COA 2026-003
766 Old Fitzhugh
Shed to Accessory Office
Space Conversion

Certificate of Appropriateness Review
June 4, 2026

766 Old Fitzhugh Proposed Shed-to-Office Conversion Elevations

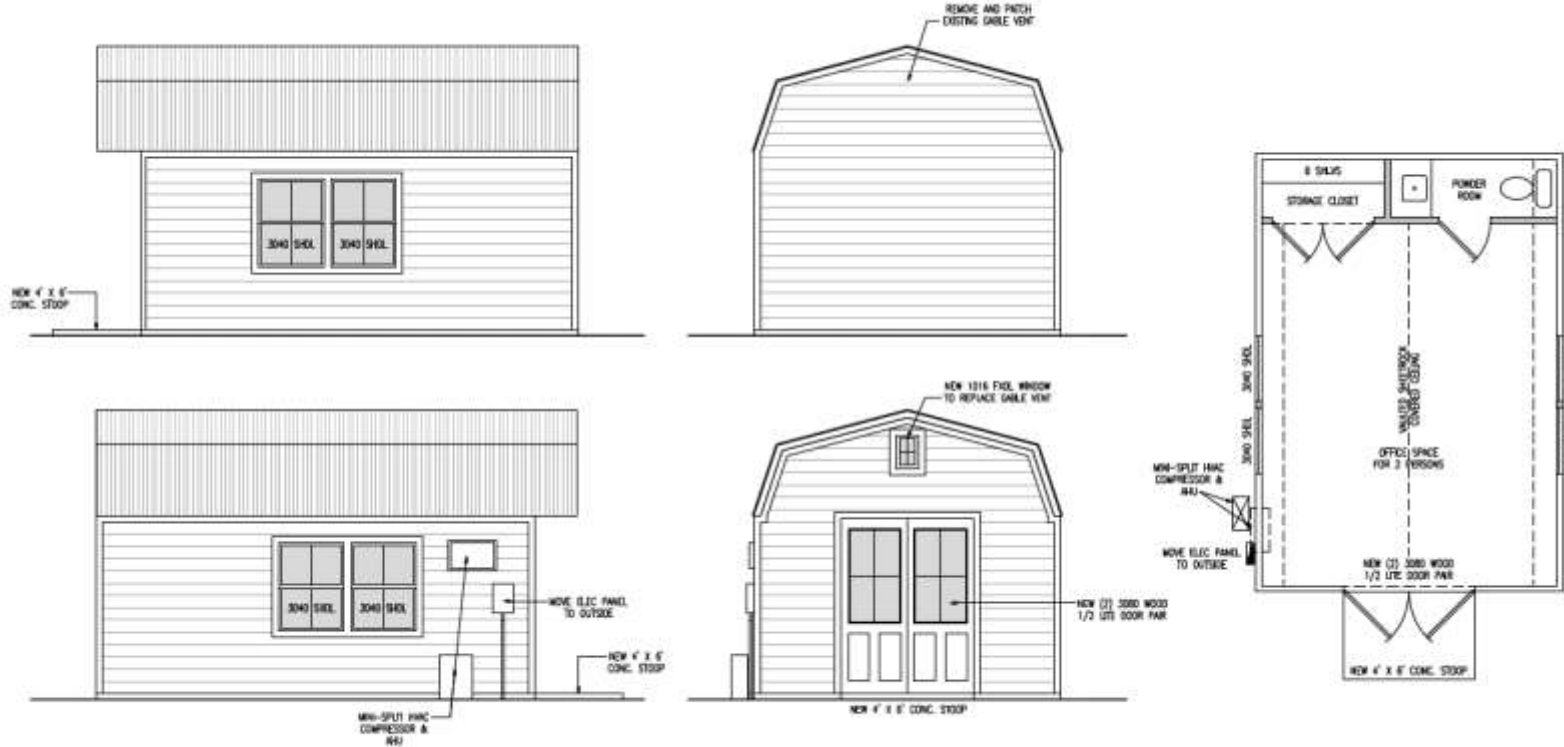
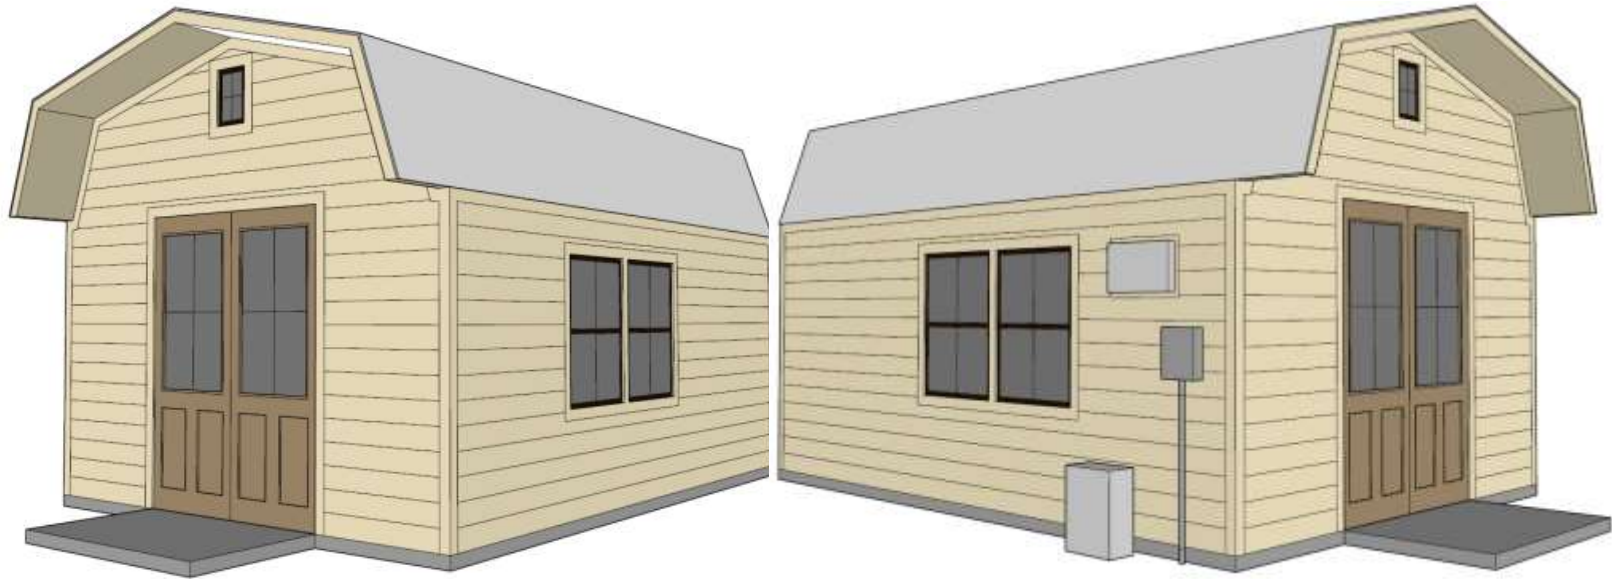
The submitted project description and renderings appear to follow the guidelines of the Old Fitzhugh Rd Historic District.

Staff recommends approval of the Certificate of Appropriateness for the shed to office conversion based on the following conditions:

- a. SW 7008 Alabaster for the main body of the building
- b. SW 6258 Tricorn Black for the front door, roof fascia, siding trims and window trims

Proposed Paint Scheme Update

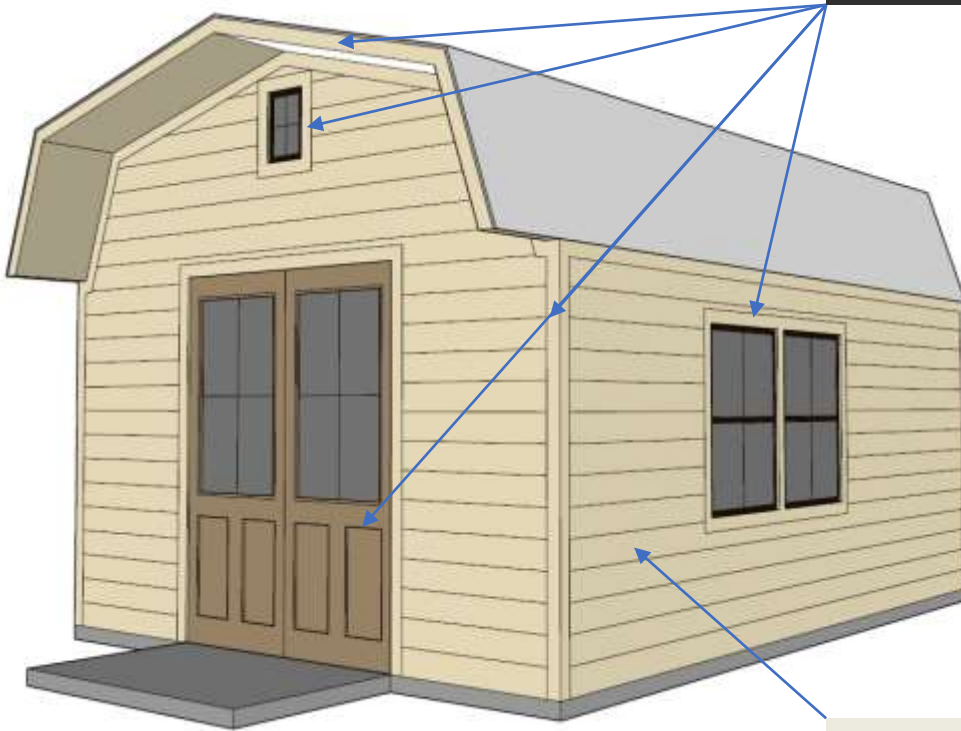
Staff recommends the following updated paint scheme:

- a. SW 7008 Alabaster for the main body of the building
- b. SW 6258 Tricorn Black for the front door, roof fascia, siding accent trims and window trims
